**Project Name: UNIVERSITY OF CALIFORNIA, MERCED
EMERGENCY EYEWASH CORRECTION**

Project No.: 907024

ADDENDUM NO. 1
to the
CONTRACT DOCUMENTS
October 17, 2018

Drawing Title
Second Floor

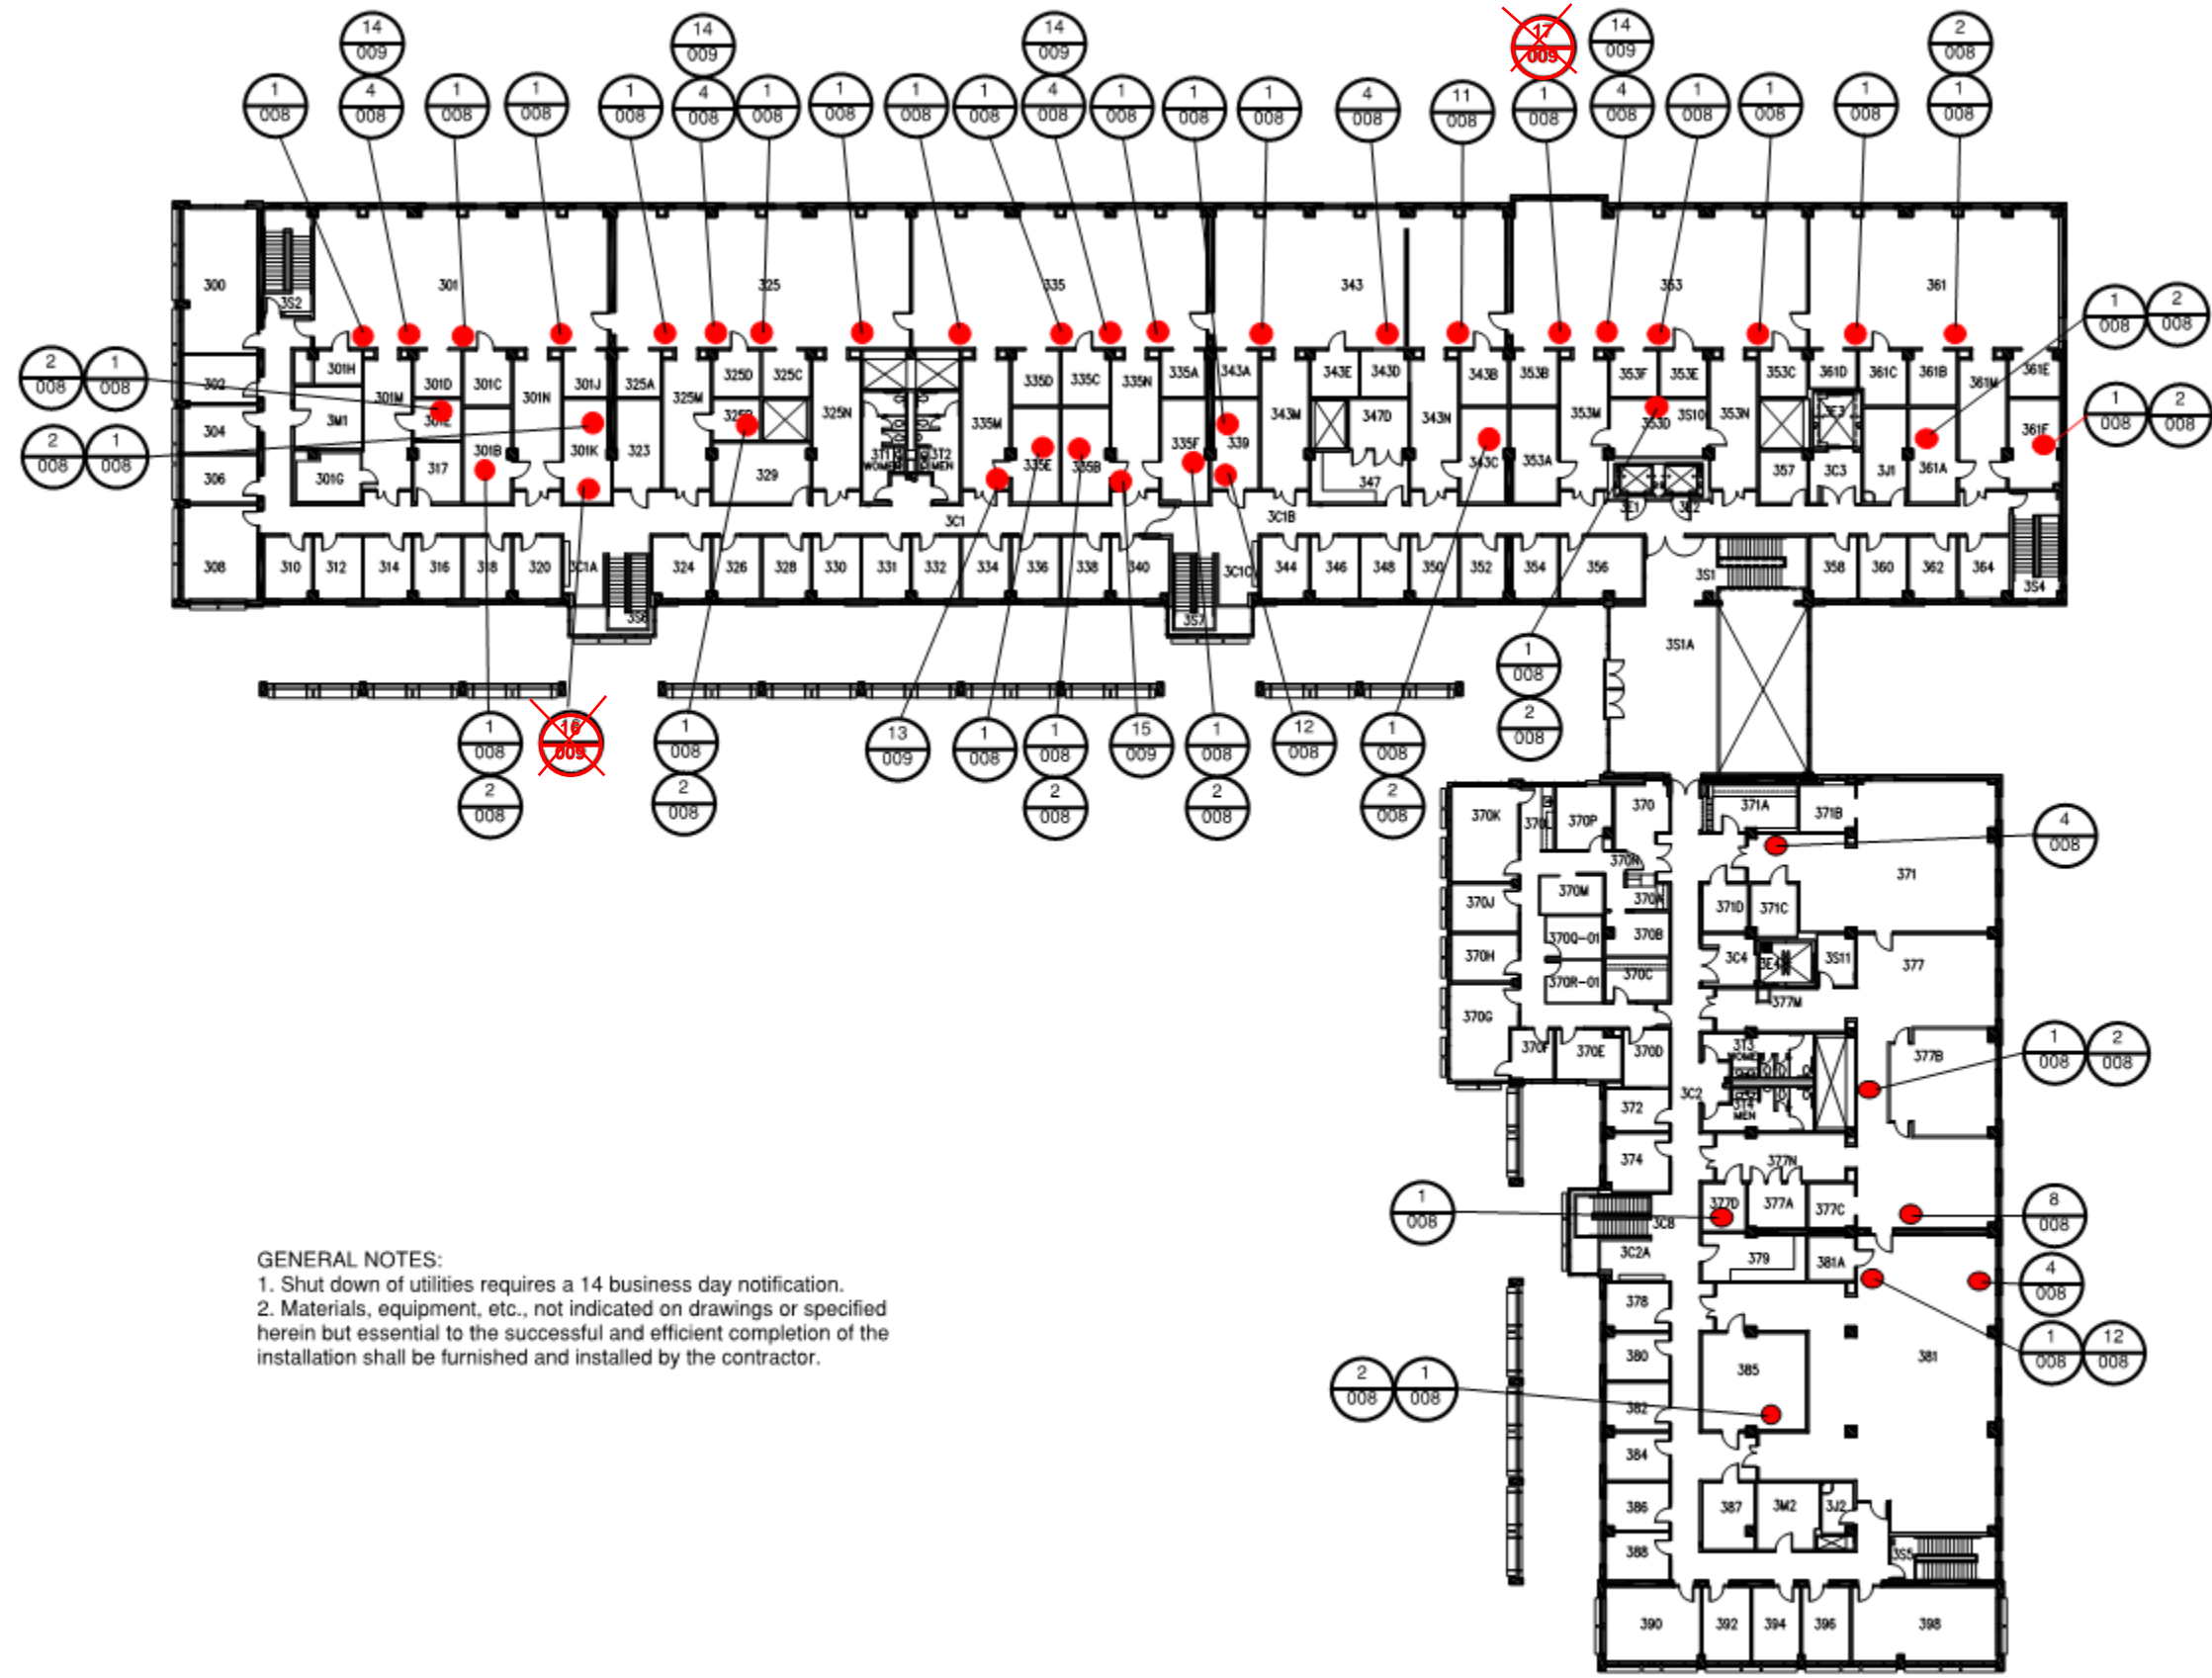
1. Installation of new emergency shower/facewash combination unit: For testing purposes, the drain is to be 24.5" above finish floor and facing away from the adjacent wall.
2. Room 201K – remove door, plate all hinges and strikes.
3. Room 301K – Cylinder rack has been relocated, remove from scope.
4. Clips on existing eye wash units may be modified to meet the 5lbs. pull requirement.
5. Additional job walk request for site observation is scheduled for October 24, 2018 @ 1:00 pm, meet in the Lobby of SE1.
